Mottagare:		Datum:	Bilaga Service	Blad nr:
Kontrollanter, kontrollantelever,		2019-10-09	Bulletin	1 av 1
CI alla klubbar		Ärende:		
		Materielvarning nr. 2019/2		
Fastställd av MK:	Ersätter:	Utfärdare:		
2019-10-09		SFF Materielkommitté (MK)

MarS Service Bulletin 02/09/2016

3. Subject : m2 AAD Cutter Replacement

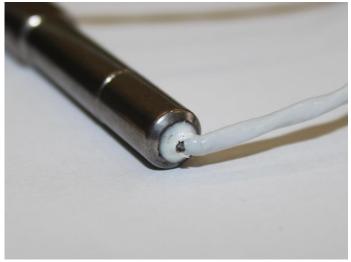
The cutter cable insulation has cracked on some MarS m2 AAD cutters as shown in Fig. 1. Investigation by the manufacturer has shown that this is caused by the method used to close and seal the cutter body. The cracking only affects the insulation, and the function of the device is unaffected. However, as a precaution, all cutters that are affected by this bulletin must be replaced.

- a. If a problem exists with the cutter this will be detected by the control unit and displayed as an error No.2. In this case, the cutter must be replaced immediately.
- b. If no error is detected, then the AAD may remain in use until the next repack cycle. During the next regular repack the cutter must be inspected and replaced if it is affected by this bulletin.
- c. The rigger shall make an entry on the packing data card stating that the installed cutter is not affected by the bulletin.
- d. A replacement cutter may be obtained directly from MarS, or from an m2 distributor. The affected cutter should be sent to the manufacturer, or to an m2 distributor.
- e. The cost of the replacement cutter and of shipping the replacement cutter to the user will be covered by the manufacturer.
